**Subject: Manual extinguisher bracket**

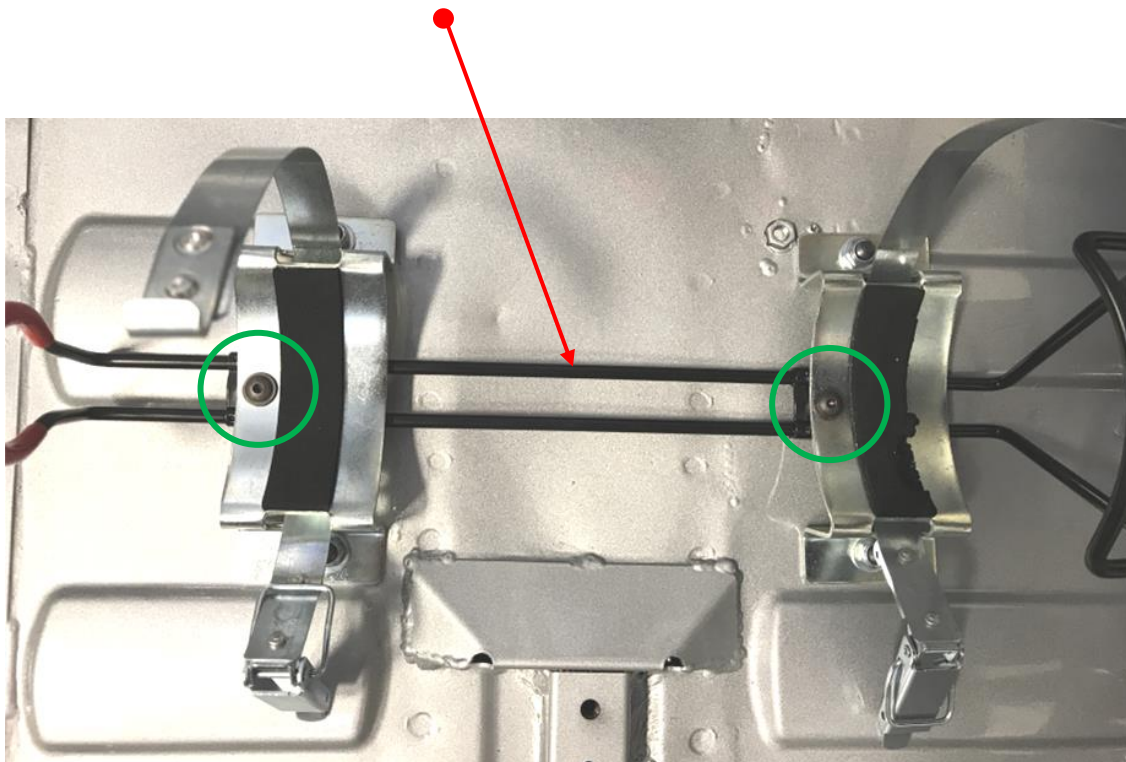
Following some recent notifications from the FIA about the fixation of the manual extinguisher, it is now mandatory to fit the **anti-torpedo** device to the 2 brackets (for example with **2 screws ULF M5x10** ref PS74009A01 + **self-locking nut M5** ref PS74009A01).
